Final Environmental Impact Statement for the
Site Plan Application of Breezy Hill VI, LLC Asphalt
and Concrete Crushing, and Screening Facility
1792 Middle Road, Calverton, NY
SCTM No. 600-100-2-4.2

Lead Agency:
Town of Riverhead Planning Board
200 Howell Avenue
Riverhead, New York 11901
3-17-2022

3.0 Substantive Comments to the Breezy Hill DEIS with Lead Agency FEIS Responses..... 10

FIGURE 1-6

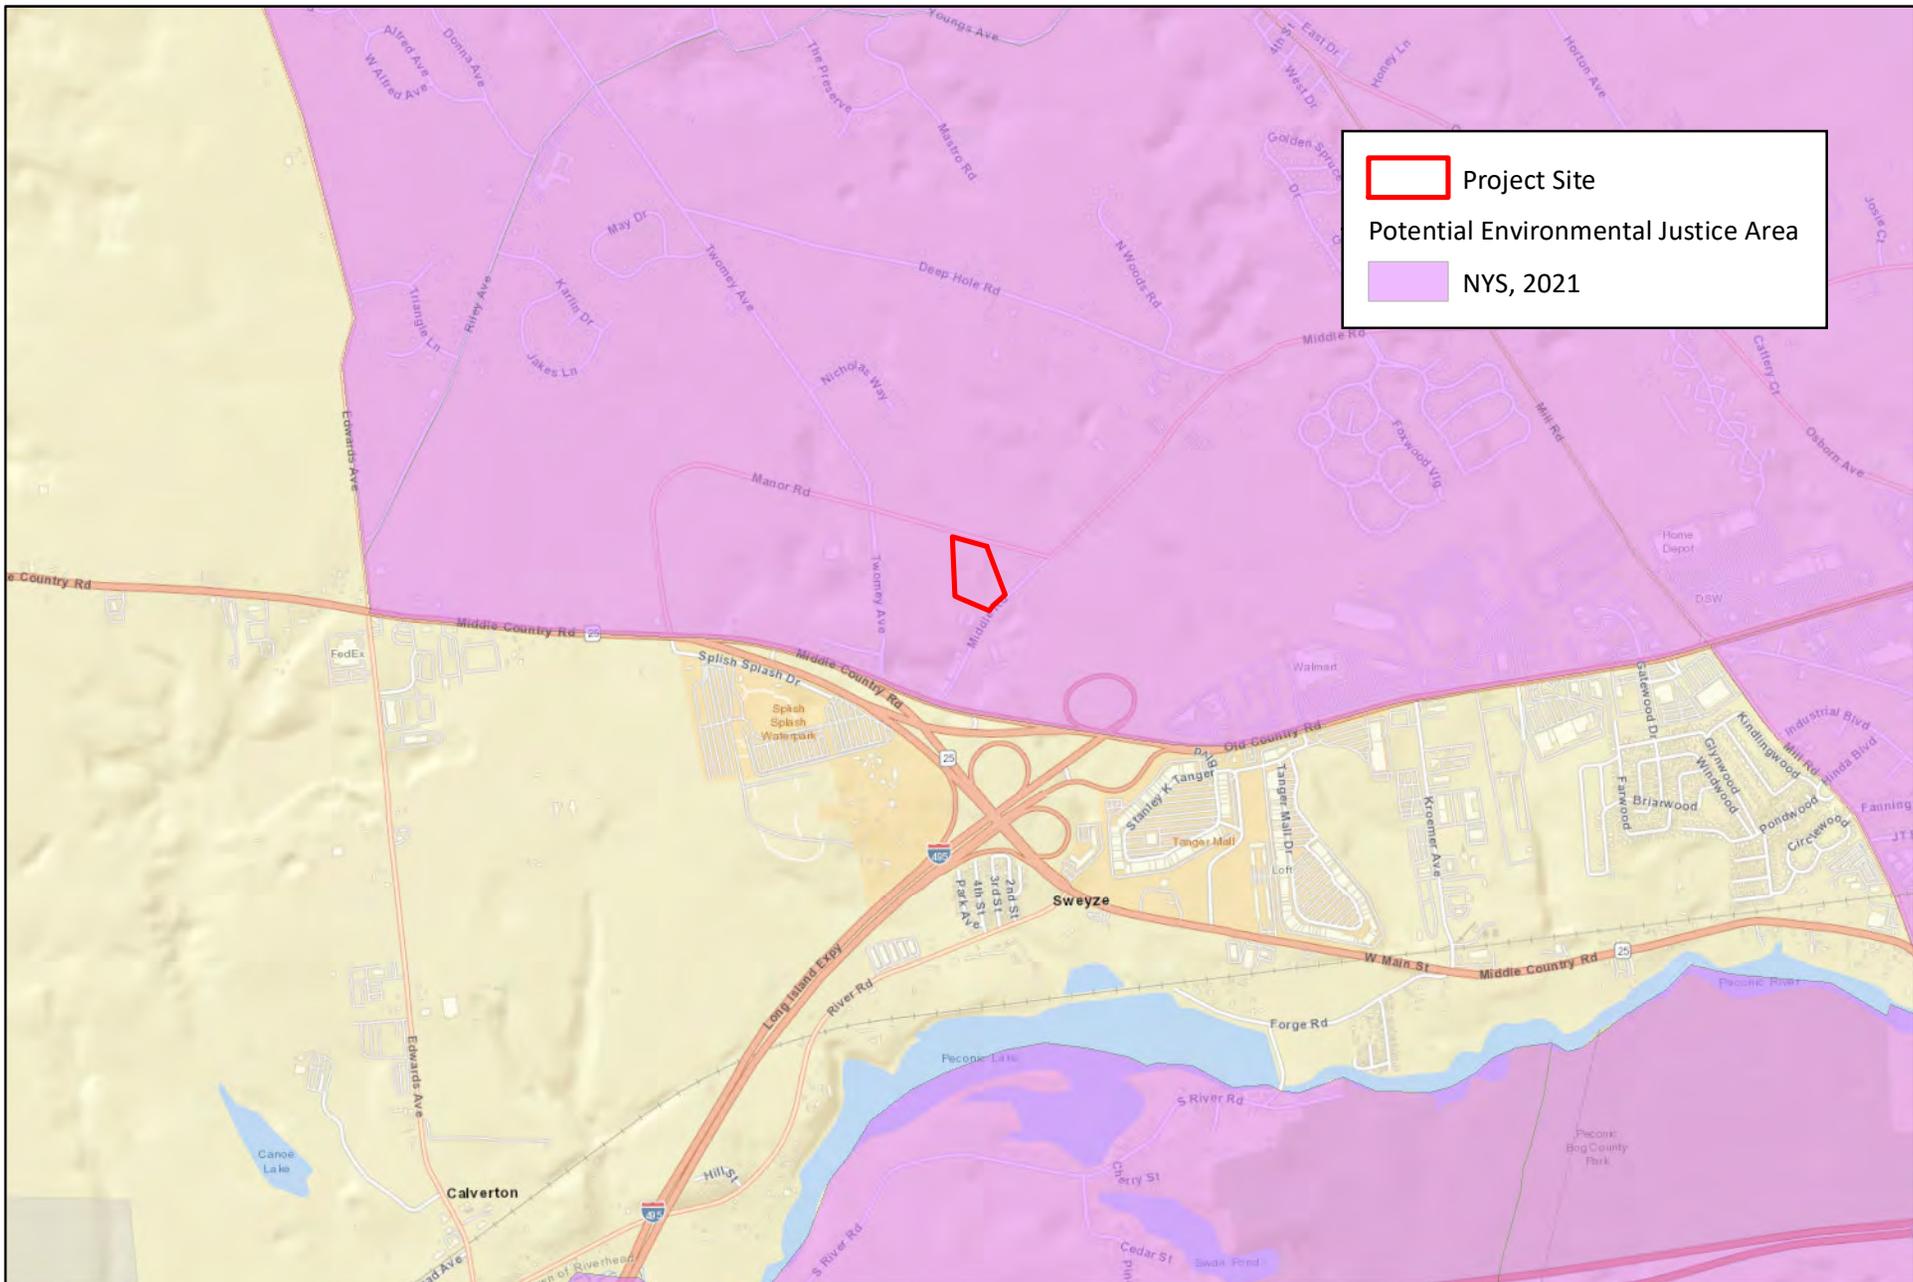
The Lead Agency required the Applicant address the issue of locating the proposed solid waste management facility in an Environmental Justice Area (EJA). The Applicant provided a reiteration of the NYSDEC's Guidance Document and general requirements but offered no specifics on how the Applicant plans to address the issue (other than a general statement towards future NYSDEC EJA compliance). There was no evaluation of alternate site location(s) outside the EJA, no "draft" public participation plan or outreach program described (albeit each is required as per the NYSDEC Guidance Document). The Lead Agency expected the Applicant provide a comparison of the proposed action to the alternative uses studied in the DEIS and offer discussions with respect to the EJA. The Lead Agency determined the Applicant's response to be minimal and non-responsive to fulfill SEQRA level assessment. The response to the EJA concerns is unacceptable.
